Addendum to Environmental Impact Assessment

Project Number: 44007-013
September 2017

PRC: Jiangxi Fuzhou Urban Integrated Infrastructure Improvement Project

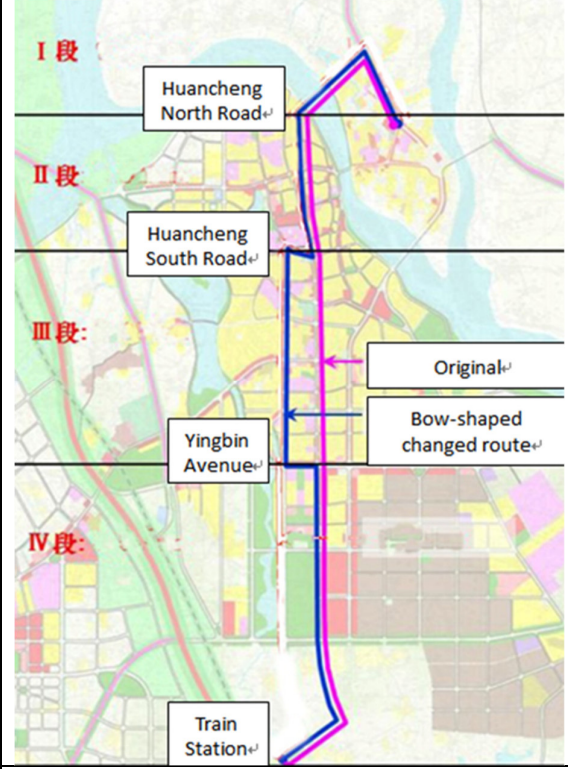
5. The re-alignment Fuzhou BRT route is a bow-shaped route, starting from XinJianZiKou, via Wenchang Avenue – Gandong Bridge – Gandong Avenue north – Huancheng South Road – Yuming Avenue – Yingbin Avenue – Gandong Avenue south – Zhanqian Avenue and ending at a BRT terminal at the Fuzhou train station hub square. The re-aligned BRT route is designed with total length of 13.5km and 22 bus stations with 600m average spacing. The road width is between 33-70m with bilateral 2 lanes for BRT and bilateral 4-6 lanes for other vehicles. To sum-up, the re-alignment content includes: increased length up to 1.3km, and adjusted route from Gandong Avenue corridor to Huancheng South Road – Yuming Avenue – Yingbin Avenue bow-shaped corridor. Table 1-3 provides detailed comparison between the original and re-aligned routes.

Table 4. Detailed design layout of realigned BRT routes

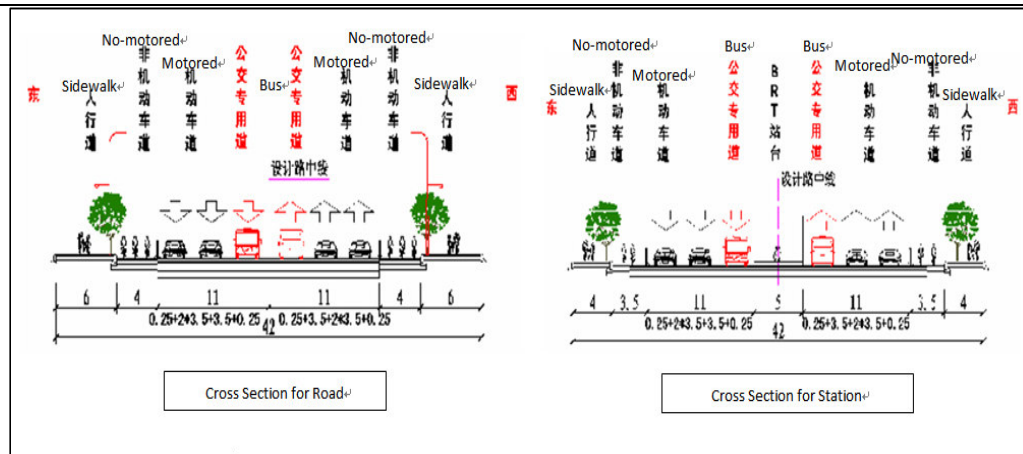
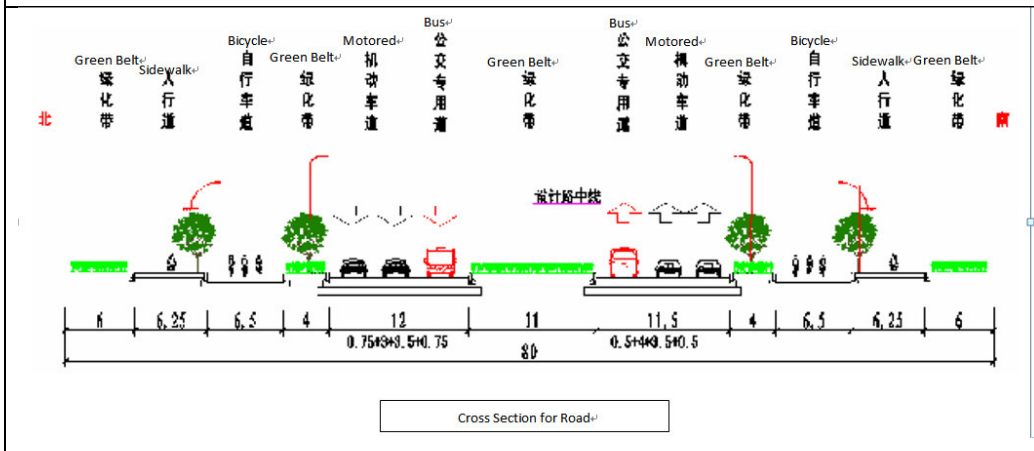
Huancheng South Road	
<ul style="list-style-type: none"> Road cross section: 26m = 2m (sidewalk) + 3.5m (bicycle lane) + 7.5m (vehicle lane) + 7.5m (vehicle lane) + 5.5m (sidewalk) Station cross section: 29.5m = 2m (sidewalk) + 3.5m (bicycle lane) + 11m (vehicle lane) + 5m (BRT platform) + 4m (vehicle lane) + 4m (sidewalk) 	
<p>No-motored 非机动车道 人行道 Sidewalk</p> <p>Motored 机动车道</p> <p>公交专用道 Bus专用道</p> <p>公交专用道 Bus专用道</p> <p>Sidewalk 人行道</p> <p>2 3.5 7.5 7.5 5.5</p> <p>0.25+2+3.5+0.25 0.25+2+3.5+0.25</p> <p>26</p> <p>Cross Section for Road</p>	<p>No-motored 非机动车道 人行道 Sidewalk</p> <p>Motored 机动车道</p> <p>公交专用道 Bus专用道</p> <p>BRT站台 BRT Platform</p> <p>公交专用道 Bus专用道</p> <p>Sidewalk 人行道</p> <p>2 3.5 7.5 3.5 5 4 4</p> <p>0.25+2+3.5+0.25</p> <p>29.5</p> <p>Cross Section for Station</p>
Yuming Avenue	
<ul style="list-style-type: none"> Road cross section: 42m = 6m (sidewalk) + 4m (bicycle lane) + 11m (vehicle lane) + 11m (vehicle lane) + 4m (bicycle lane) + 6m (sidewalk)

- Station cross section: 42m = 4m (sidewalk) + 3.5m (bicycle lane) + 11m (vehicle lane) + 5m (BRT platform) + 11m (vehicle lane) + 3.5m (bicycle lane) + 4m (sidewalk)

- Road cross section: 80m = 6m (landscaping) + 6.25m (sidewalk) + 6.5m (bicycle lane) + 4m (landscaping) + 12m (vehicle lane) + 11m (landscaping) + 12m (vehicle lane) + 4m (landscaping) + 6.5m (bicycle lane) + 6.25m (sidewalk) + 6m (landscaping)
- Only BRT lane is set in Yingbin Avenue and no station is set.

Table 5. Station layout

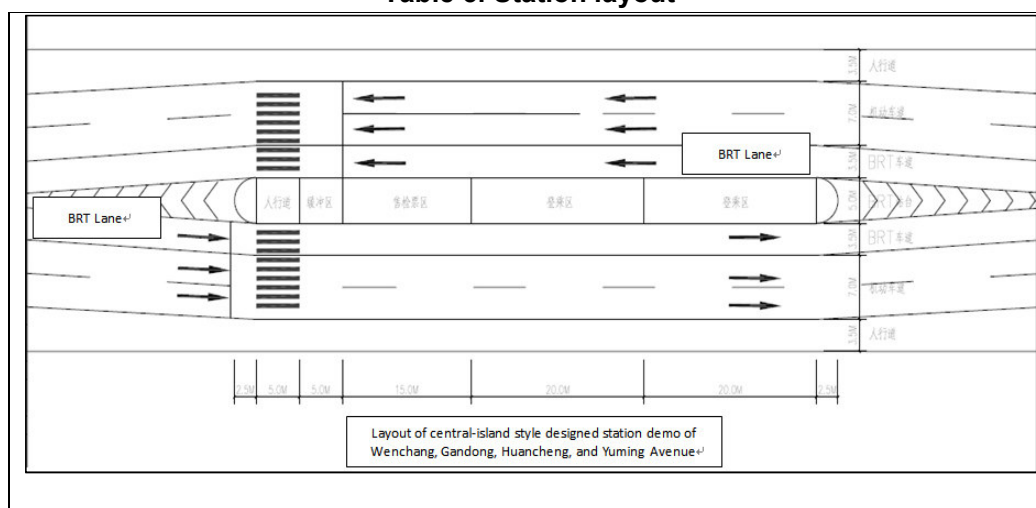
13. Bus station will be designed as island-style station. Stations will provide disabled and blind facility in line with standards. Wide emergency access will be set between fare checking areas. A total of six fire boxes will be installed in station zone including ABC and HFP extinguishers. Boarding area will provide several seats as well as special chairs for the elderly, the young, the sick, the disabled and pregnant women. Sufficient drainage will be designed and electric pipes will be hidden in the structure. The station layout picture is shown below:
